## ADDENDUM No. 2

Reference: Student Center Addition  
Utah Valley State College - Orem, Utah  
DFCM Project No: 08217790

## ADDENDUM - 2

Project: UVSC Student center addition  
DFCM Project Number: 08217790  
Axis Project Number: 0721

ADD 1- C5/ AE102  
EXPANSION JOINT DETAIL

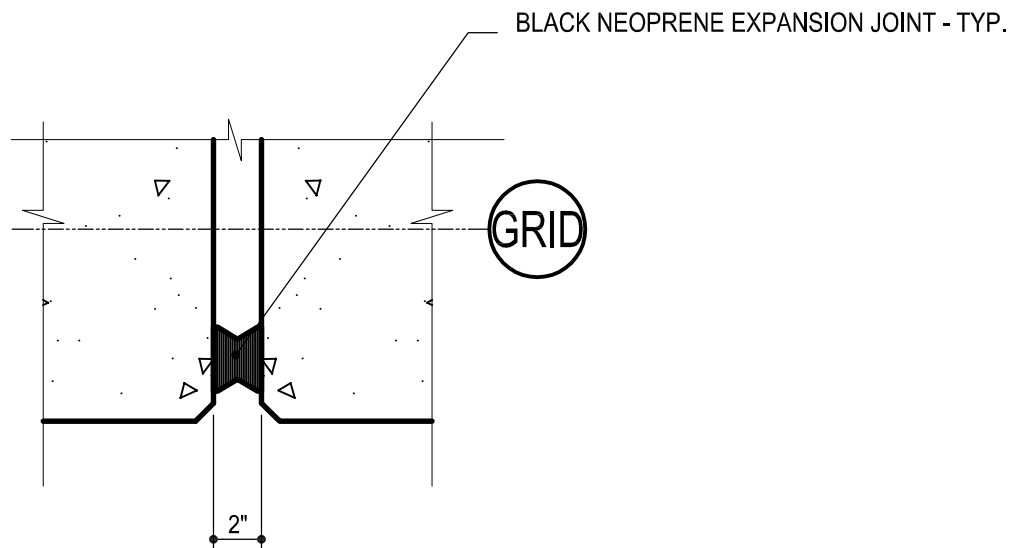
- 2.3 AE102: Add attached drawing C5/AE102. This detail applies to the two existing double beams shown on roof plan (A4/ AE102) where detail C1/AE102 is also called out. It should also be installed vertically between the 2 columns between 10'-0" AFF and 15'-0" AFF.

## C4 WALL SECTION DETAIL AT EXTERIOR

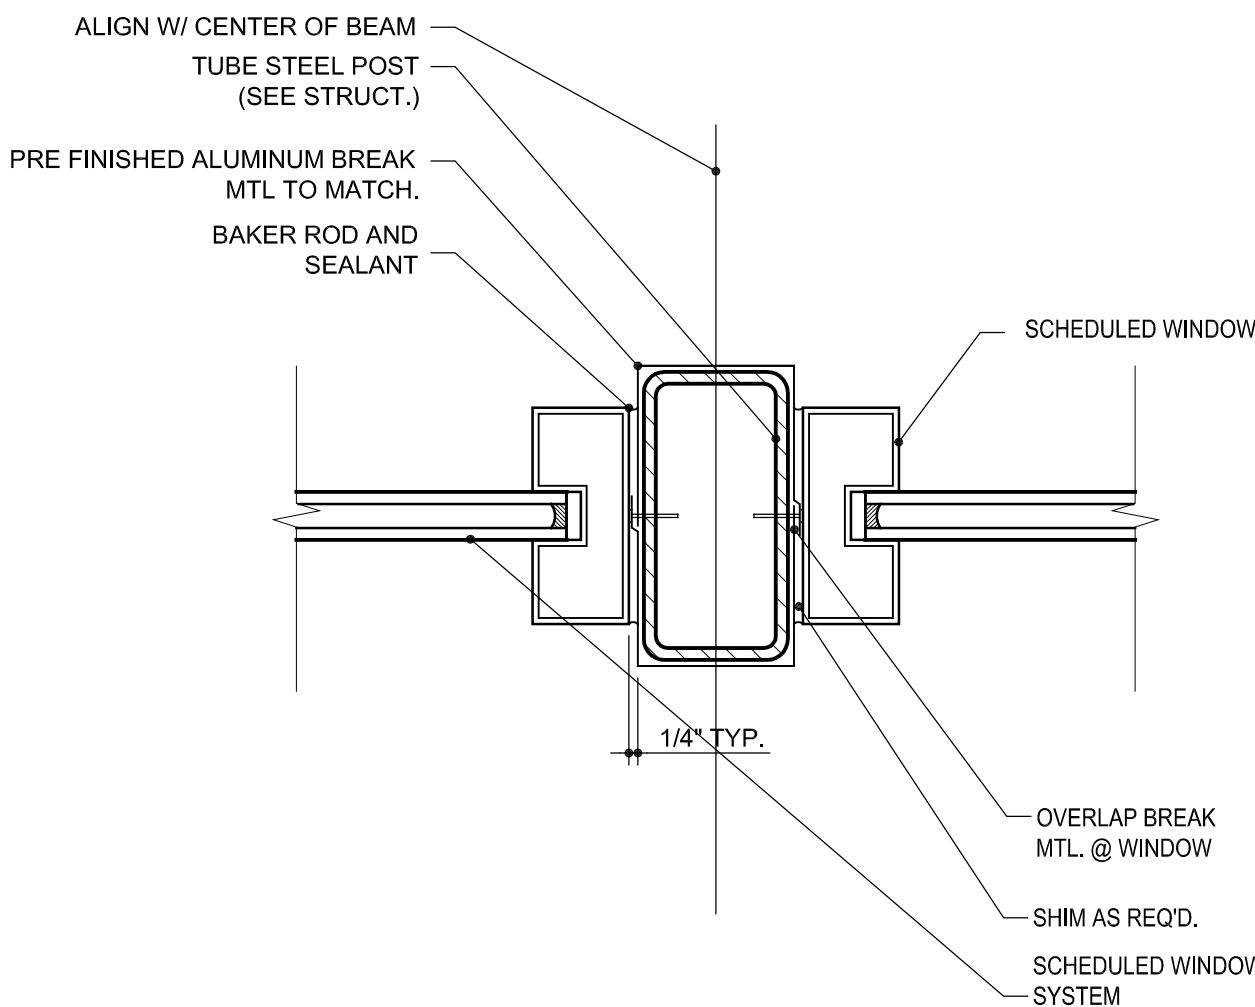
- 2.5 AE601: Replace Sheet AE601 with the attached Revised Sheet AE601. Detail C4/AE601 has been modified to show a 1/2 inch drip leg on the flashing. All flashing with a drip leg shall have a 1/2 inch minimum drip leg as indicated here; see Details C1/AE102, C3/AE102, C4/AE102, B1/AE102 as well.
